***SR9 WIDENING AND RECONSTRUCTION  
FROM SR 141 TO SR 20  
STP-1336(11), P.I. No. 121690  
Forsyth County, Georgia***

**Value Engineering Study Report  
Concept Submittal**

**re: SR 9 Widening from SR 141 to SR 20  
Project No. STP-1336(11), P.I. No. 121690  
Value Engineering Study Report**

CM-3

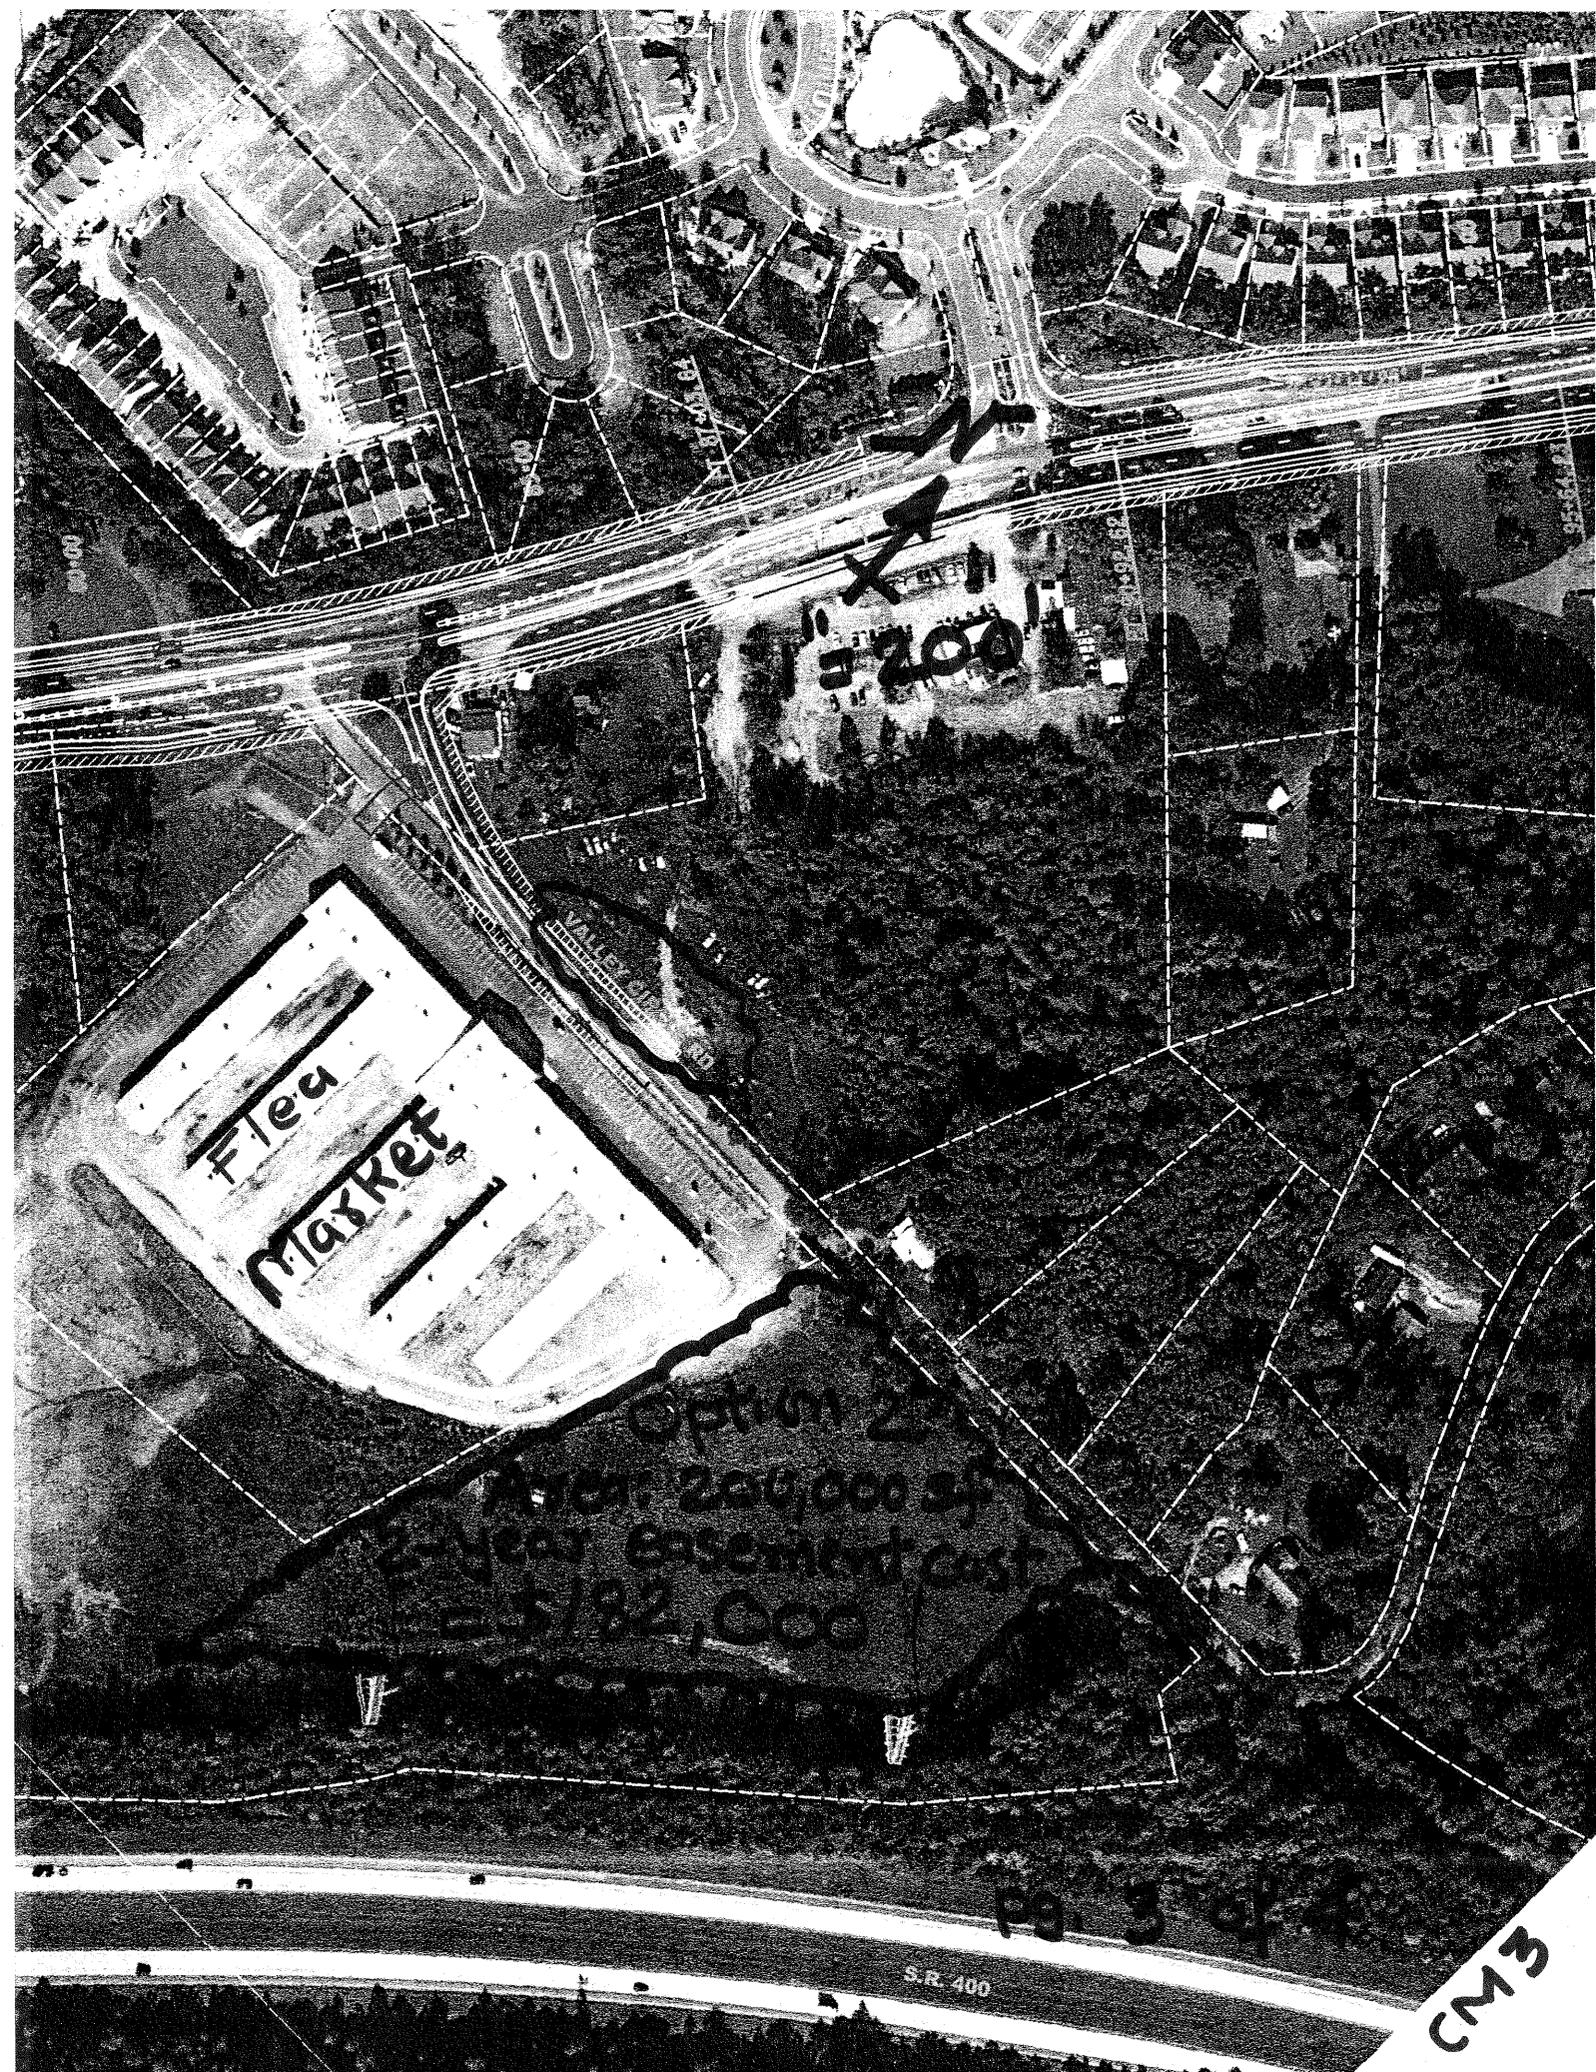
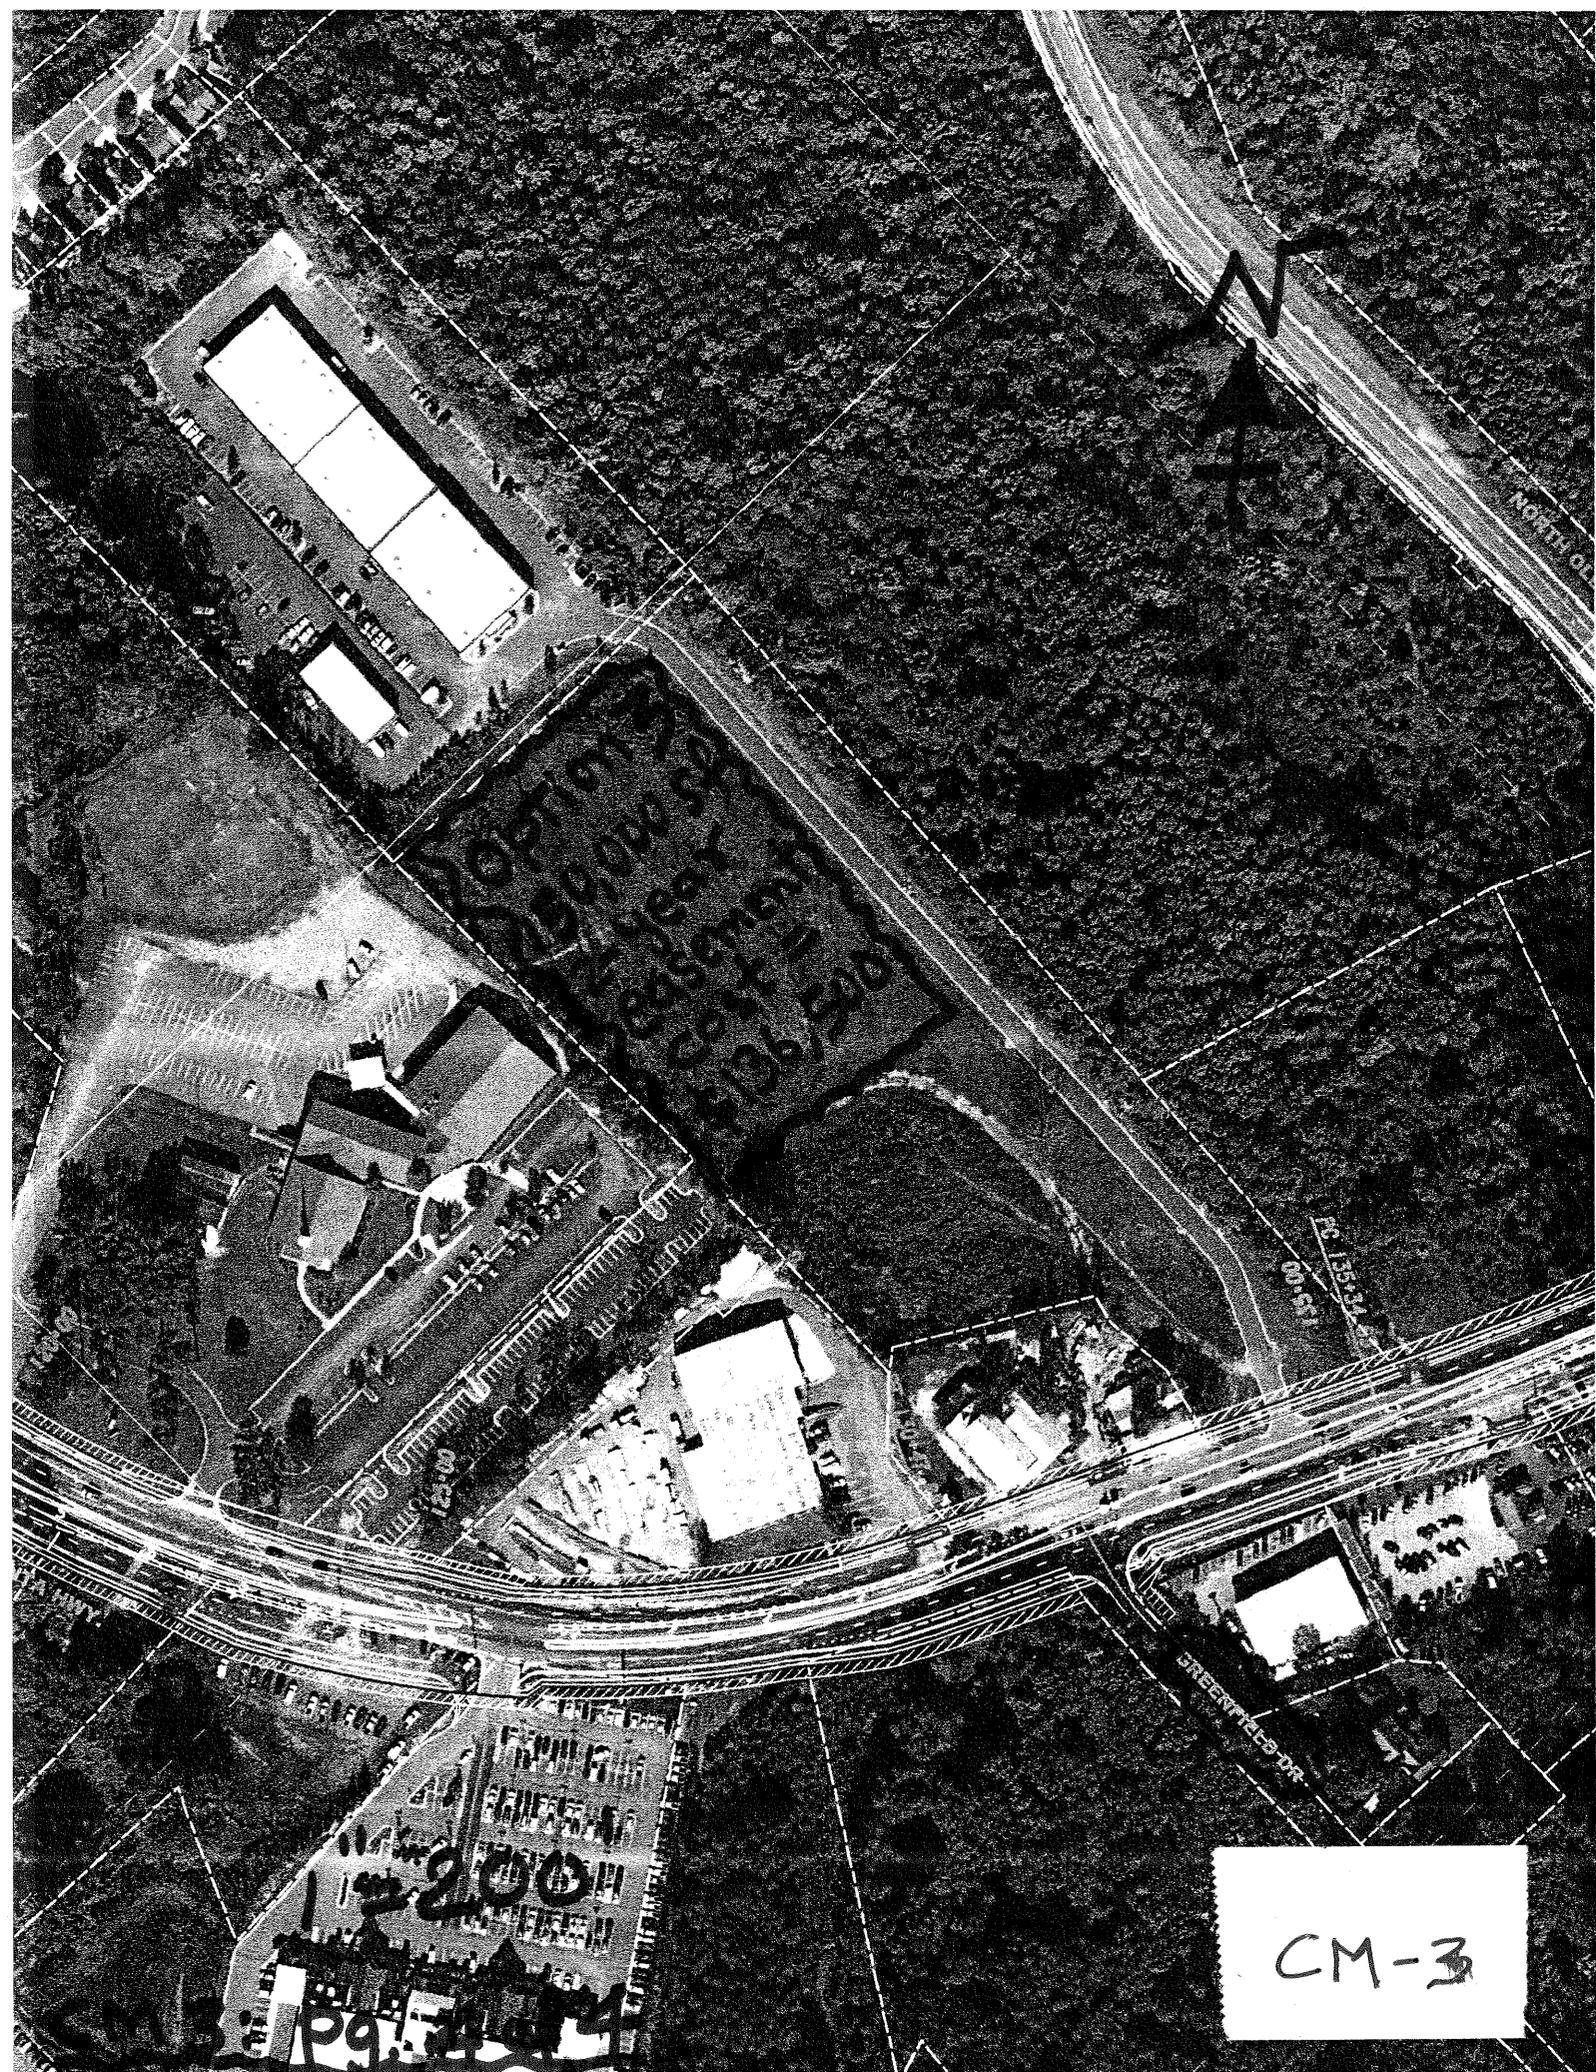
Option #2 is the most logical place to stage construction materials and equipment and employees for two reasons:
